CITY OF ALBUQUERQUE

Re: Red Rock Roasters, 4801 Jefferson St NE
Request for Permanent C.O. –Accepted
Engineer's Stamp dated: 11-14-12, (F17/D096)
Certification dated: 7-26-13

PROJECT TITLE: RED ROCK ROASTERS ZONE MAP/DRG. FILE #: F-17/D096
DRB #: _____ EPC #: _____ WORK ORDER#: _____

**Re: Red Rock Roasters, 4801 Jefferson NE,
Traffic Circulation Layout
Architect's Stamp dated 11-08-12 (F17-D096)**

F-17/DO96

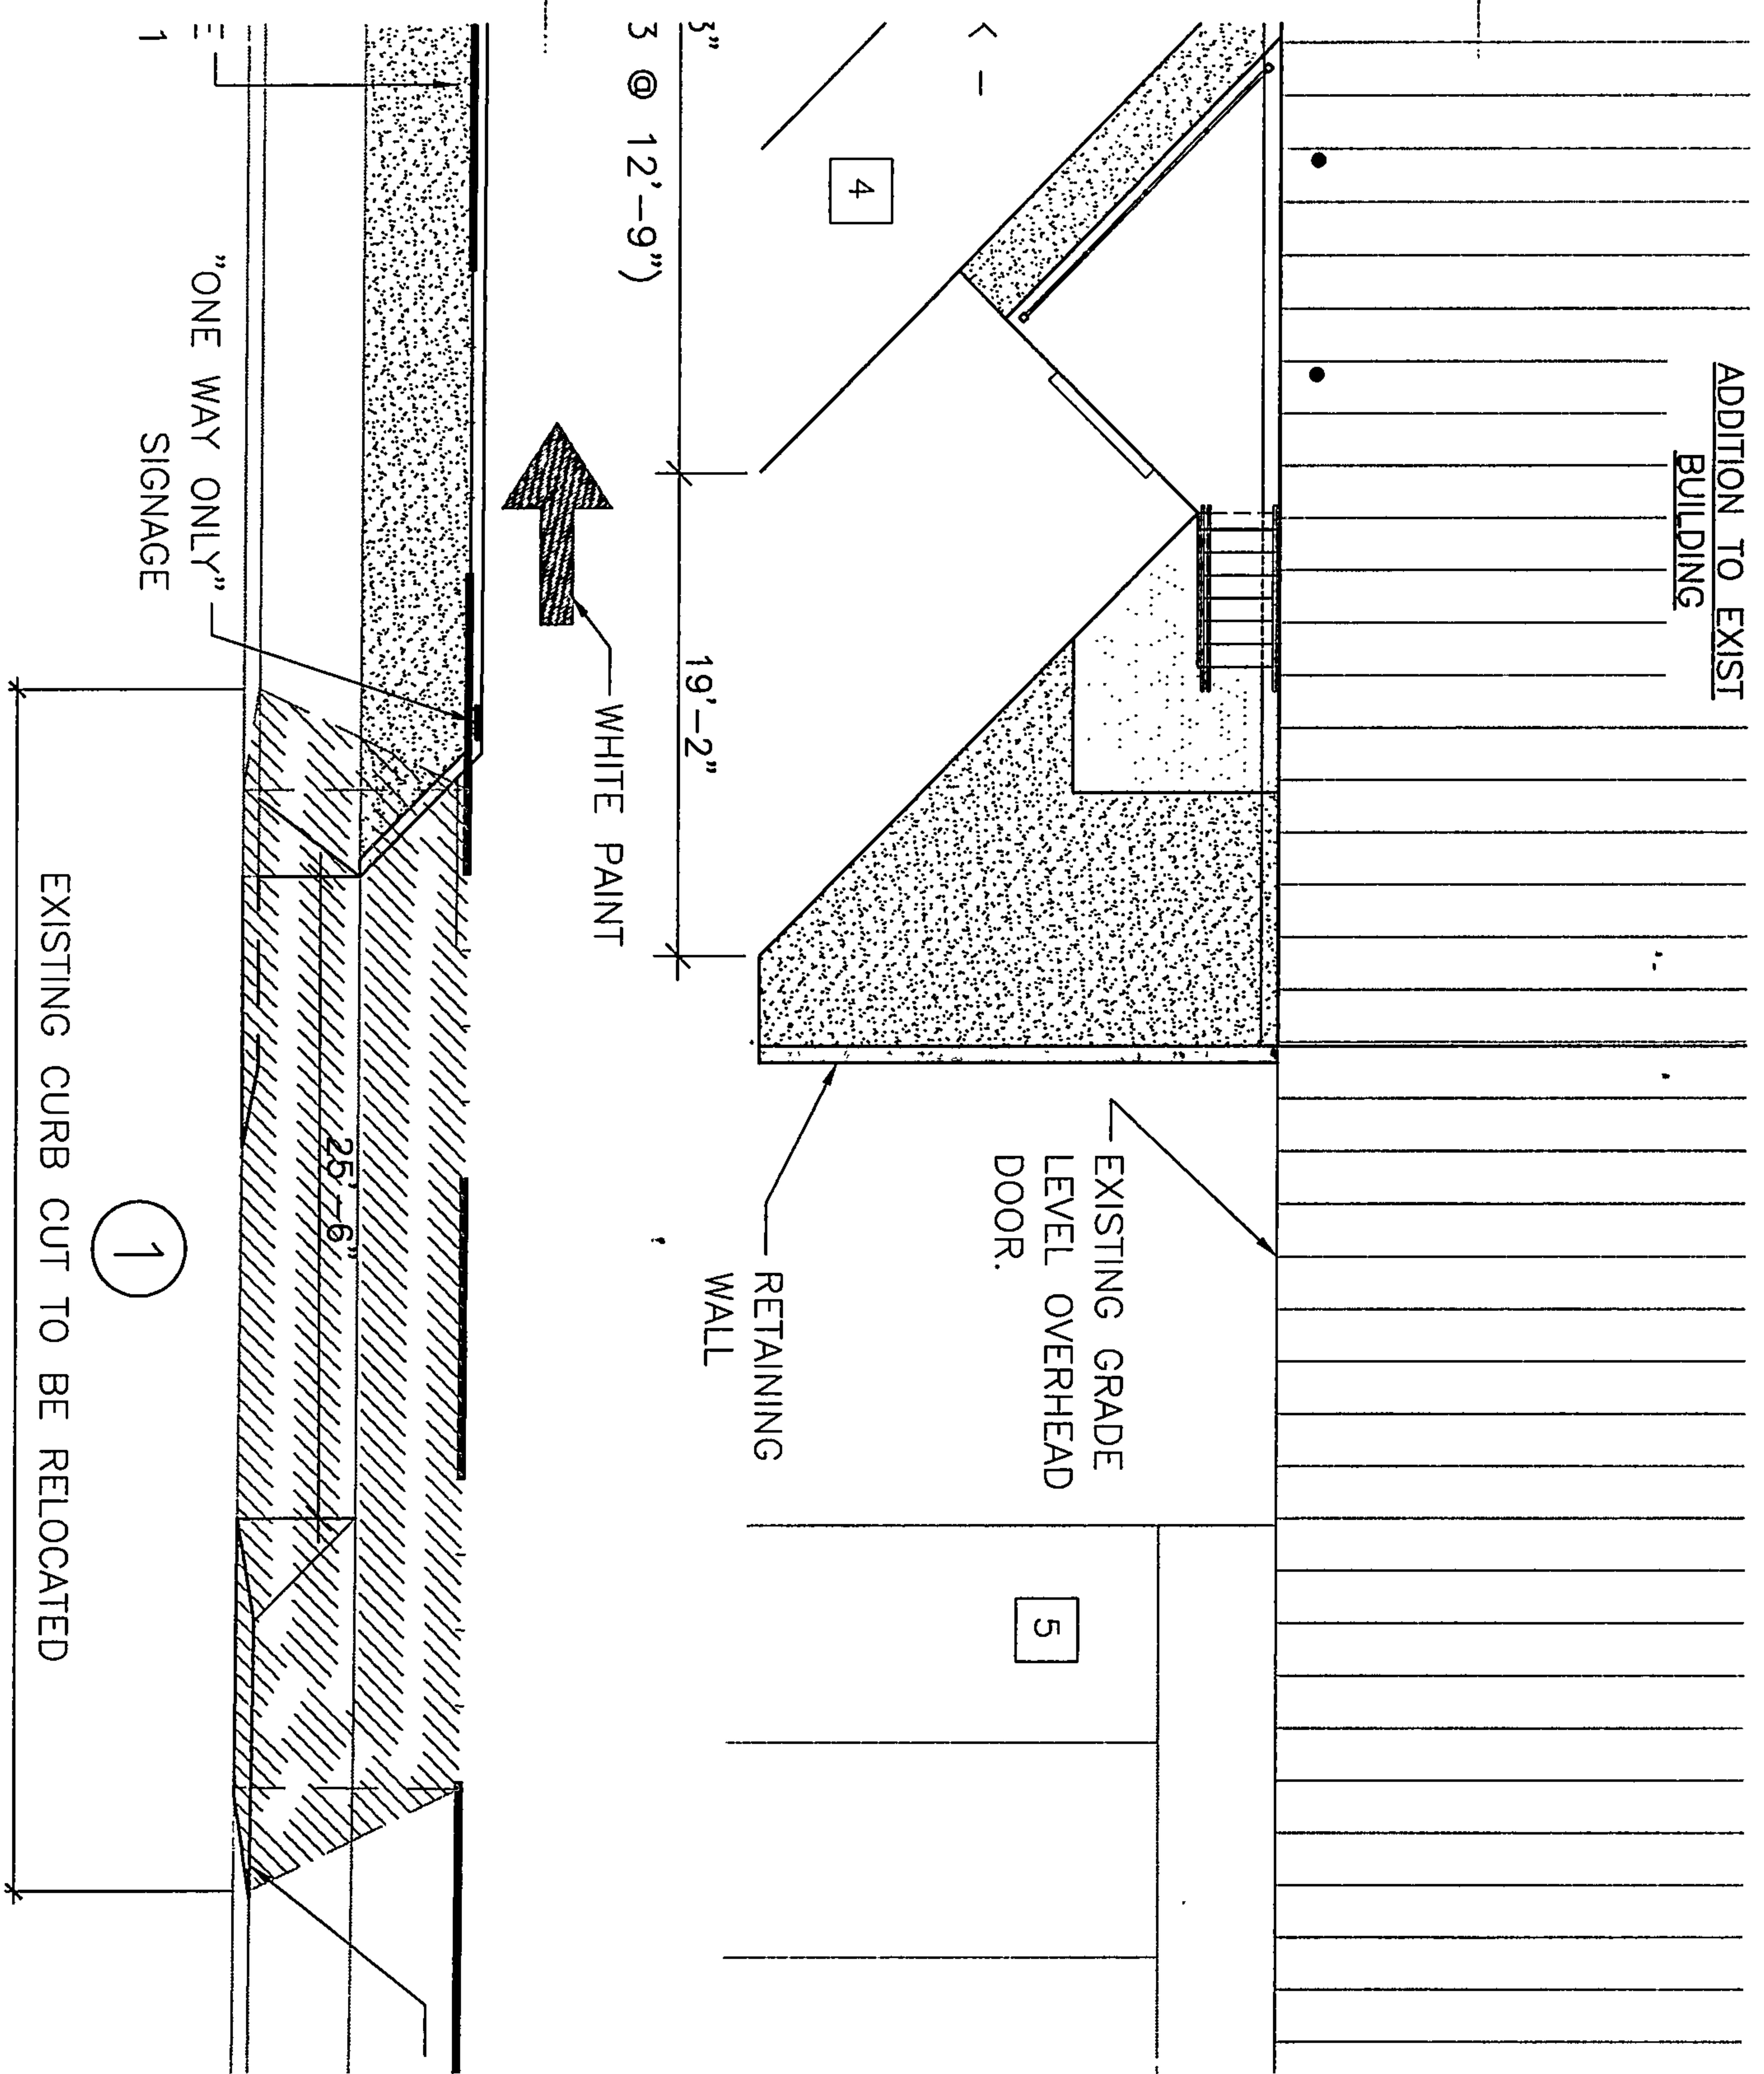
"ONE WAY ONLY"
SIGNAGE

EXISTING CURB CUT TO BE RELOCATED

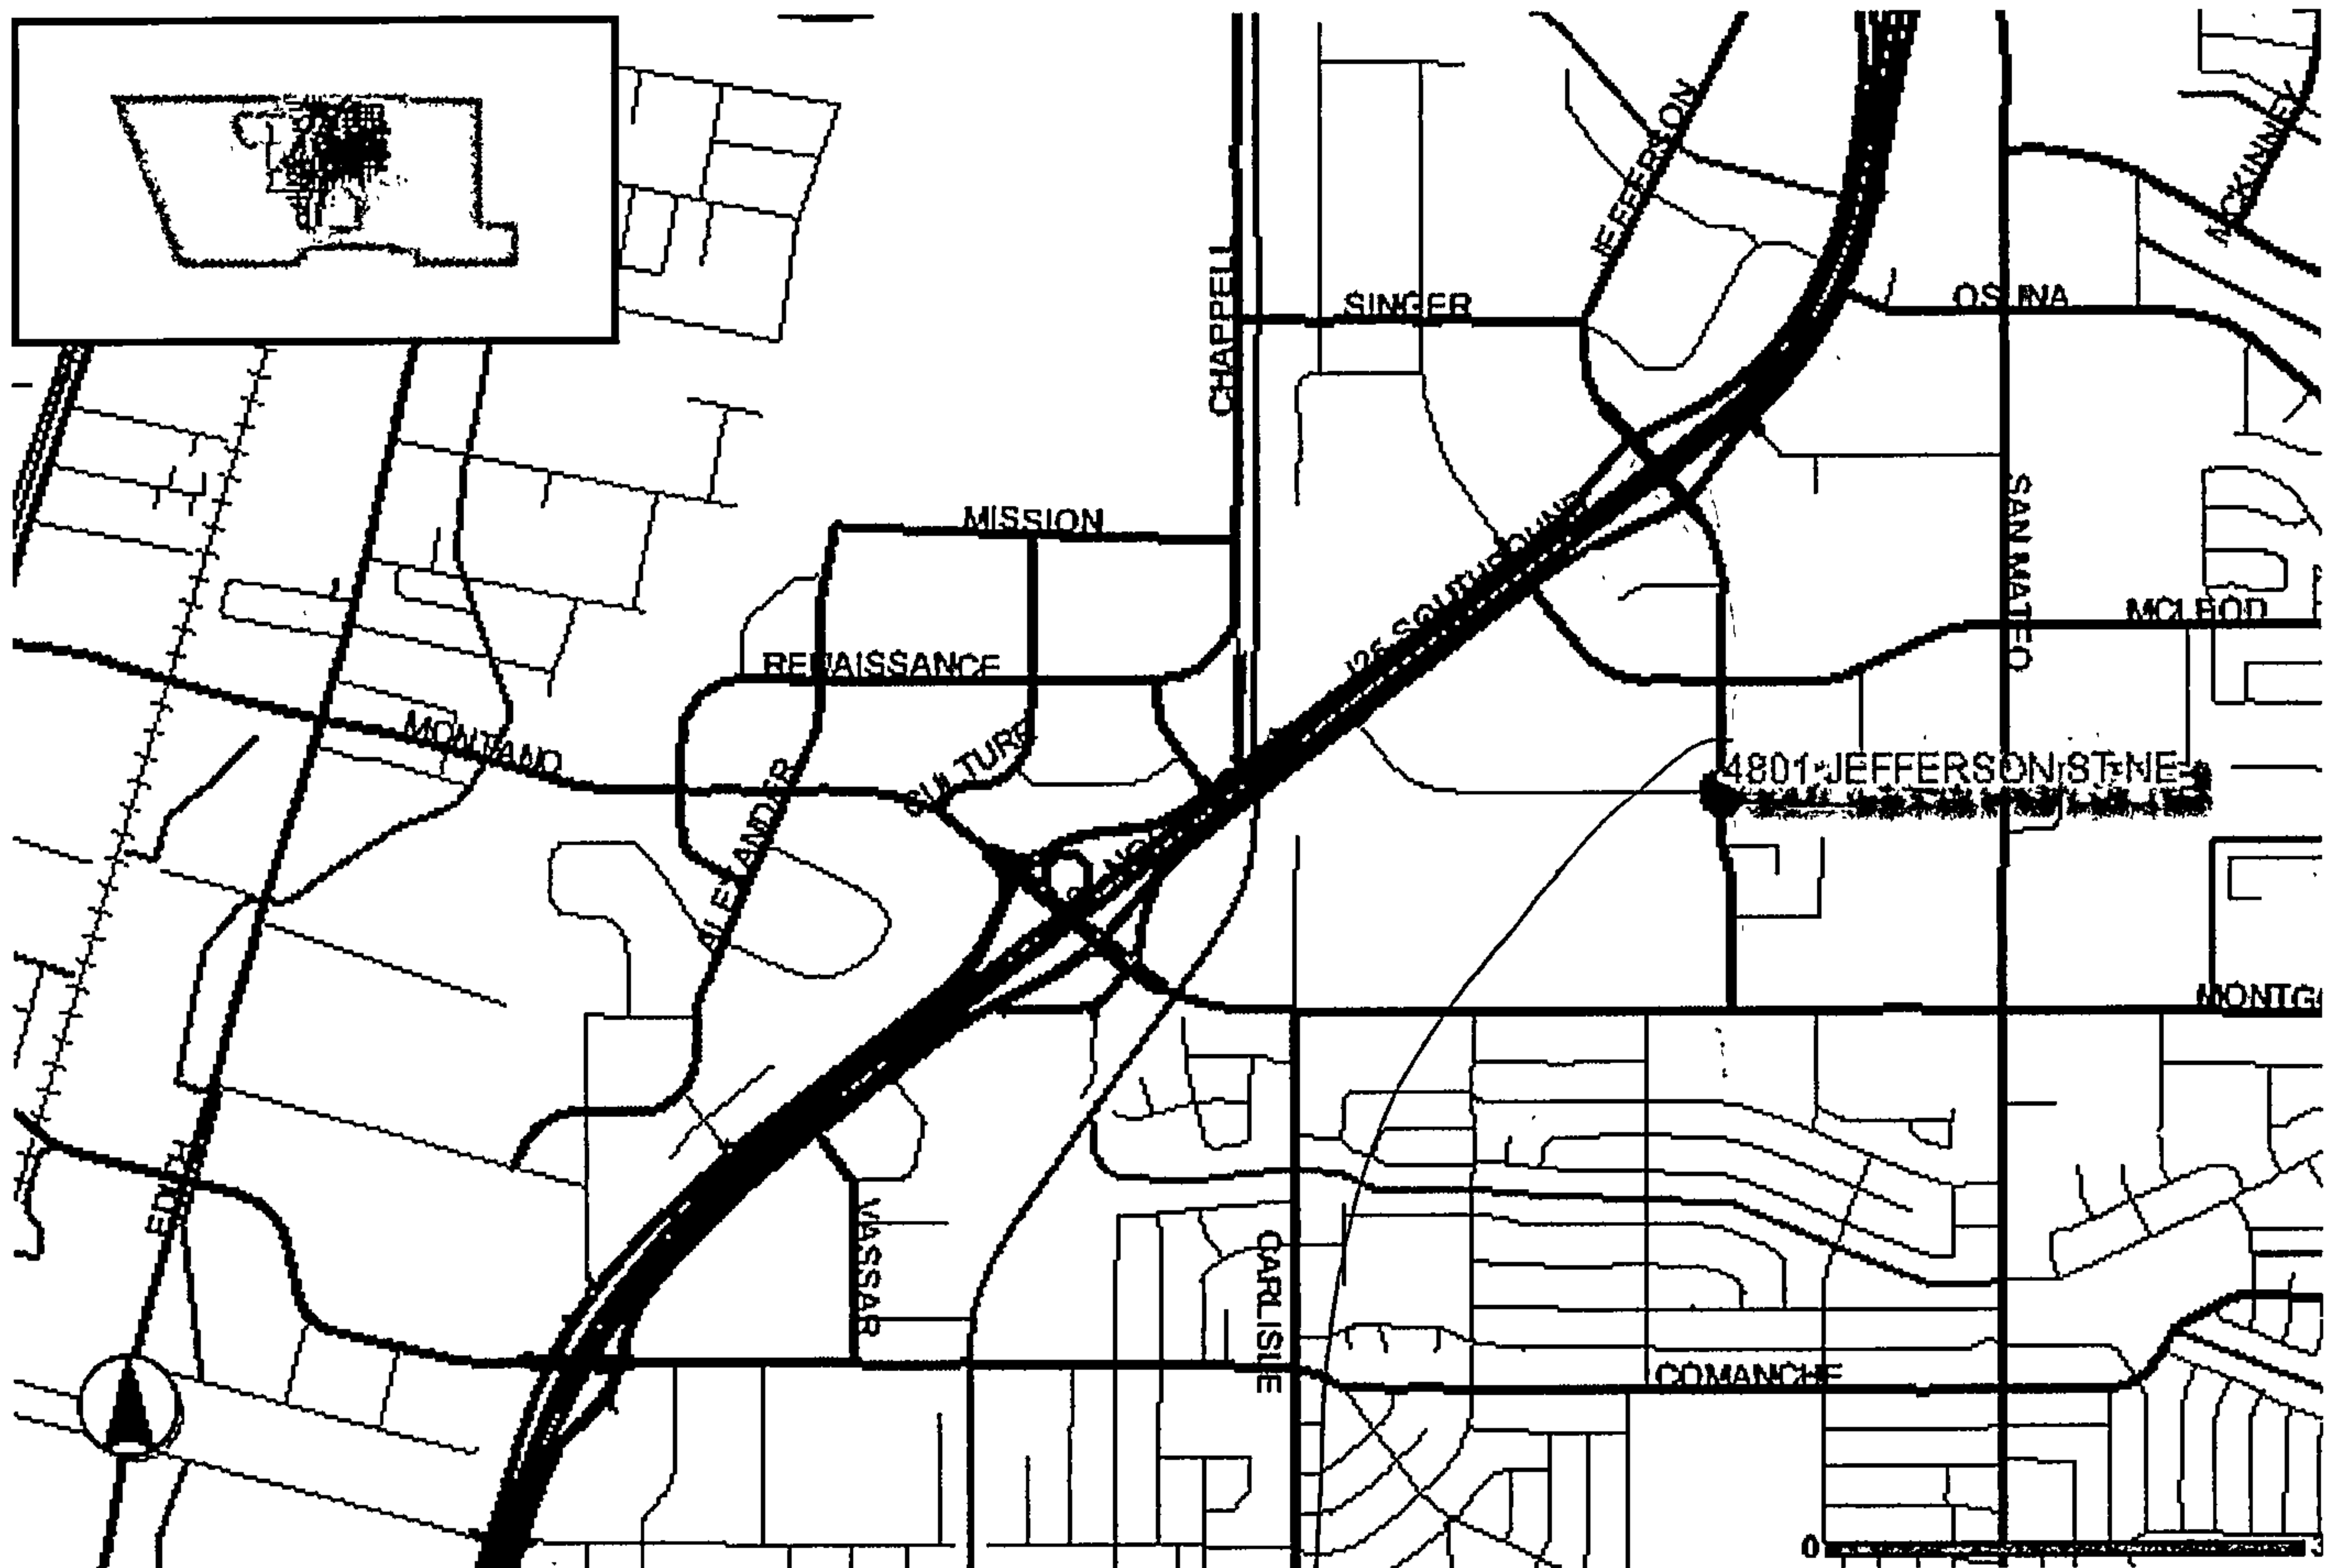
- ~~1.~~ Please route a turning template exhibit showing a minimum of 15 foot radii around all curves /corners of property for passenger vehicles.
- ~~2.~~ Please list the width and length for all parking spaces. The east lot parking spaces adjacent to building on Jefferson appear to be inadequate (scaled off at approximately 6.5ft X 11ft).

- ~~12.~~ Please provide a legend and/or keyed notes detailing line types, hatching, proposed and existing conditions for clarity.
- ~~13.~~ Please provide the refuse vehicle pick up circulation. Please note, according to DPM standards "No truck ramps, refuse/compactors or similar facilities permitted within circulation aisle. Also, "Service aisle width required: (1) two-way traffic 30' and (2) one-way traffic 20'. Additionally, the proposed location interferes with the 45 degree angled parking stall when the refuse doors are swung open.

Reverse door
